NOTICE OF OPEN MEETING
AGENDA
PLANNING AND ZONING COMMISSION
City of Moberly
City Council Chambers – Moberly City Hall
101 West Reed Street
August 28, 2023
6:00 PM

Subject: Site Plan Review Application 1245 Huntsville Rd

Notice of a Public Hearing for a site plan review application submitted by Crockett Engineering Consultants on behalf of KOSF II for improvements to the site located at 1245 Huntsville Rd.. This property is currently zoned B-3 (General Commercial District).

SITE PLAN

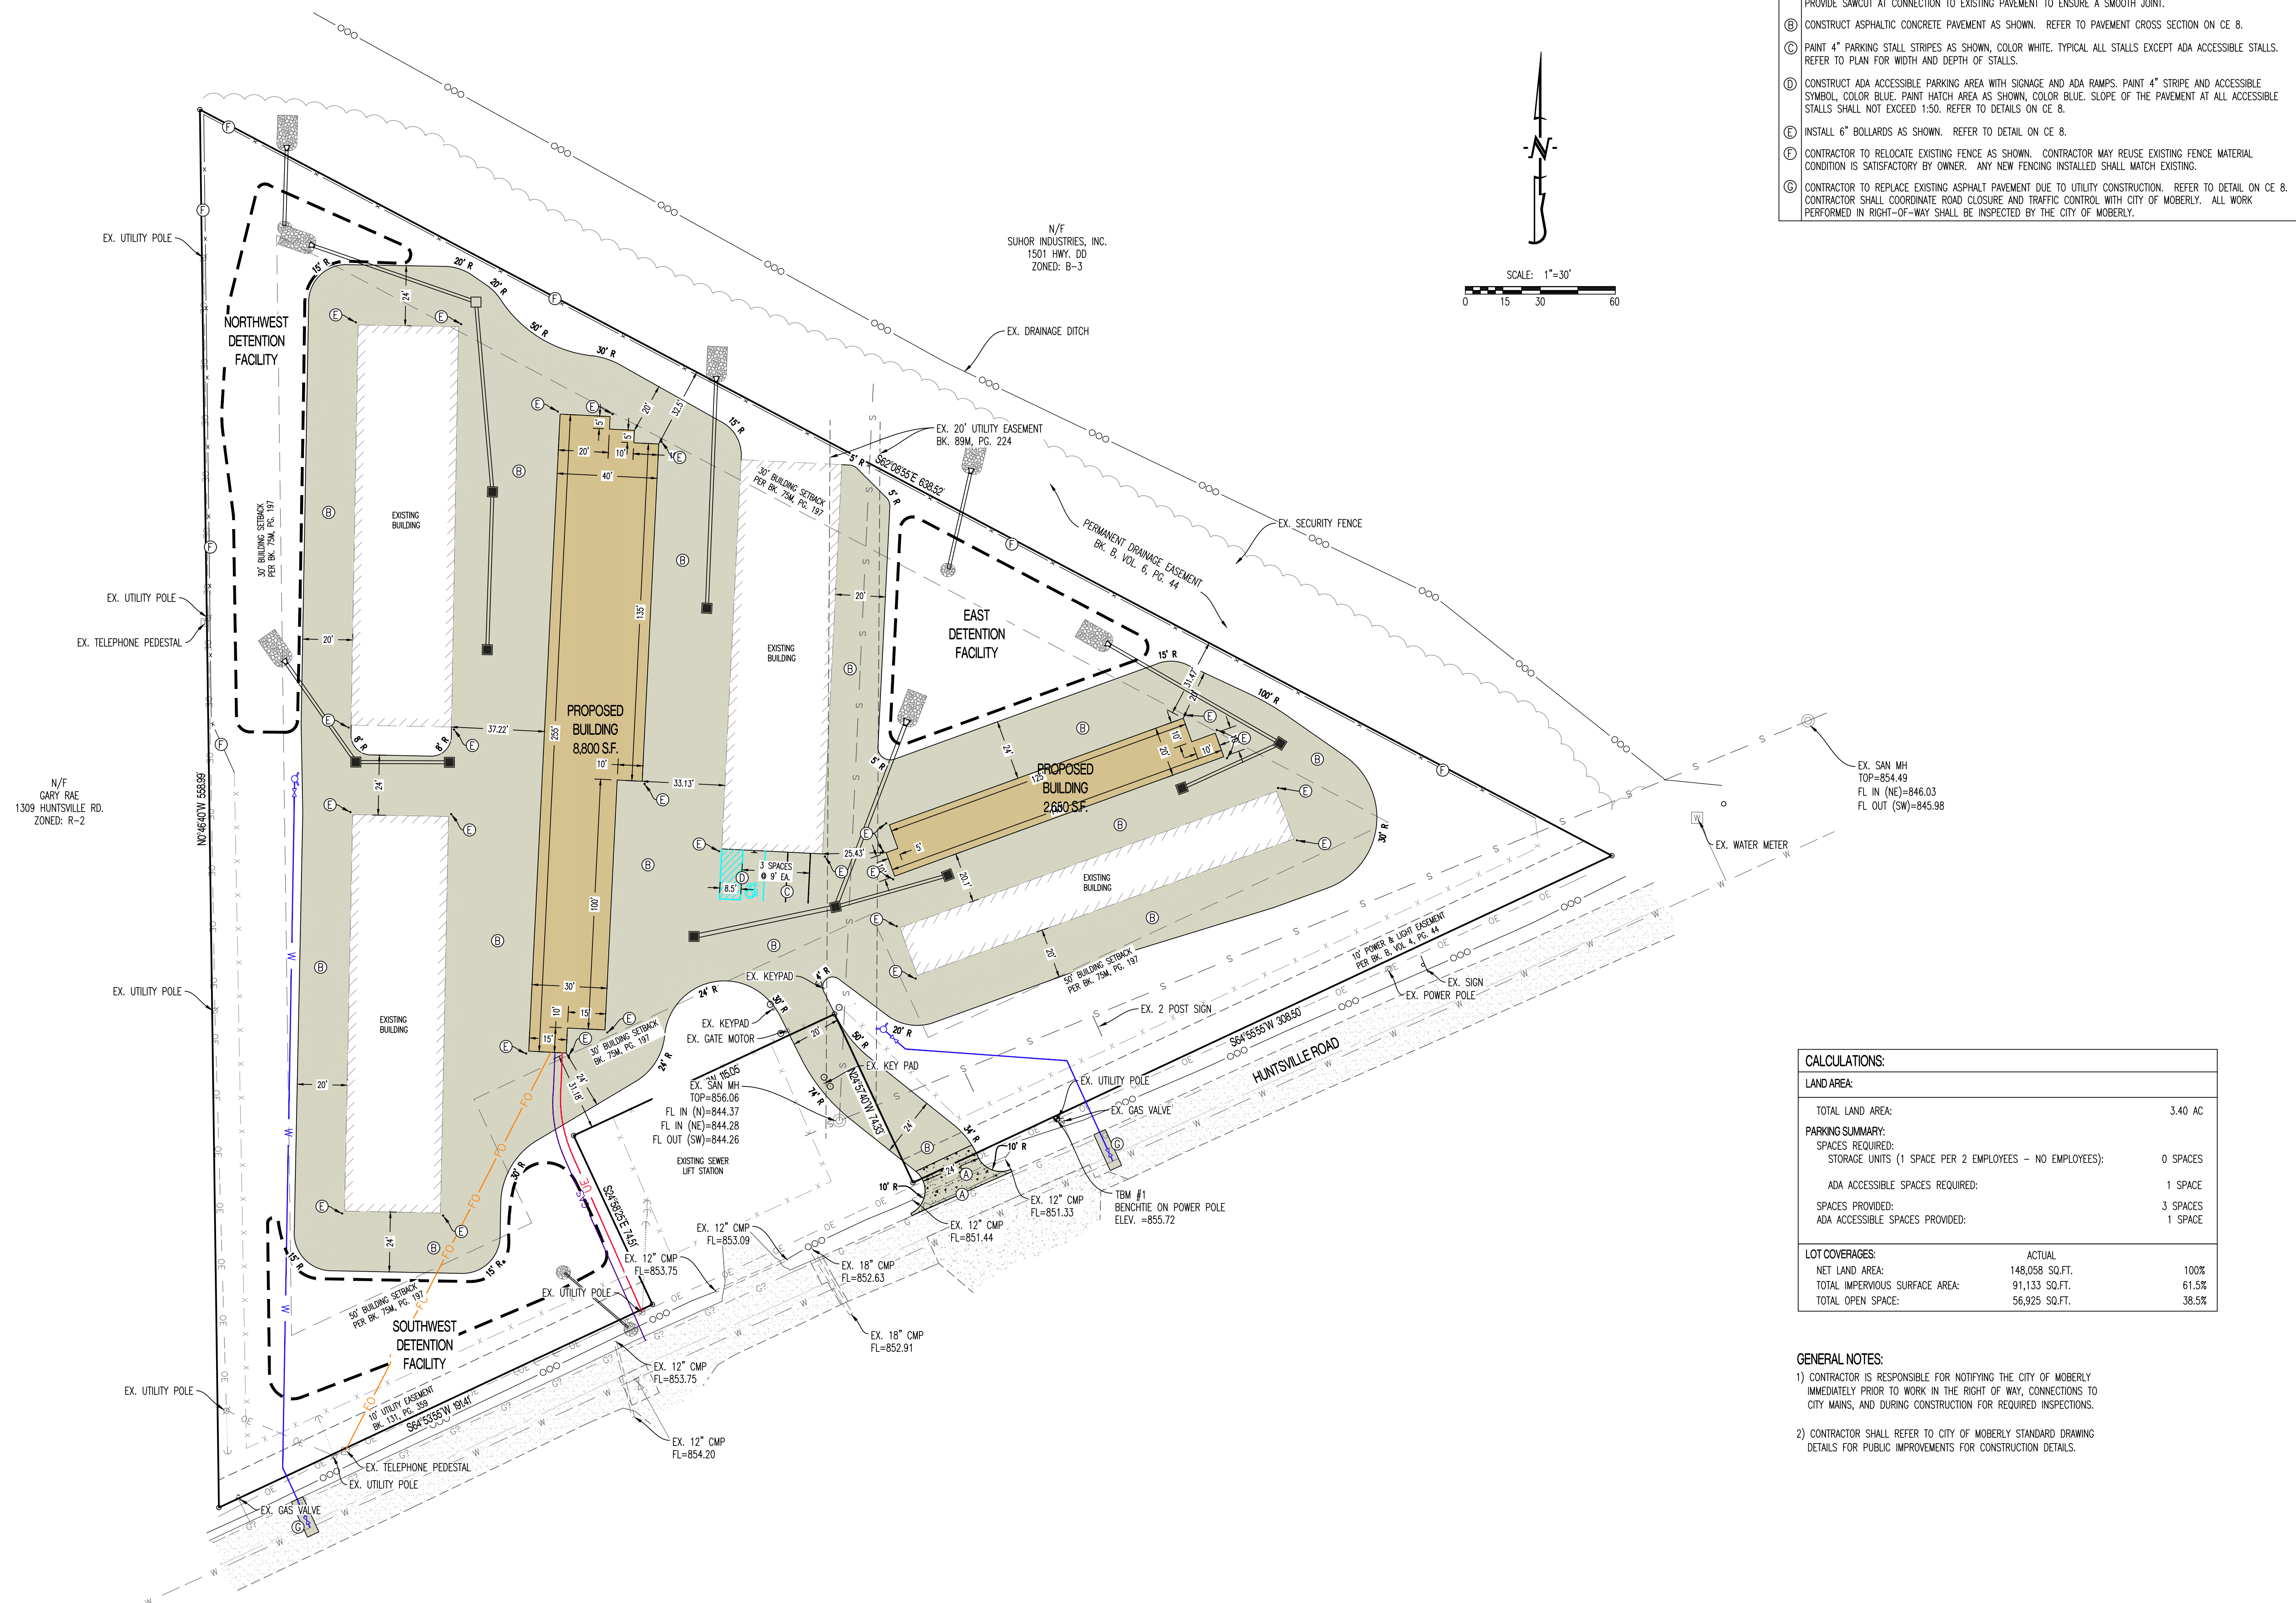
Public areas: (46-177) Parking – Improvements include paving of driving areas between buildings and also has been planned to allow fire truck access within the site.

The site plan review was reviewed by staff and Fire Department was okay with truck access between the buildings, Storm water was okay with the proposed basins, and Community Development is in agreement with the additional buildings and extra site improvements. The City Staff recommends acceptance of the site plan review as proposed.
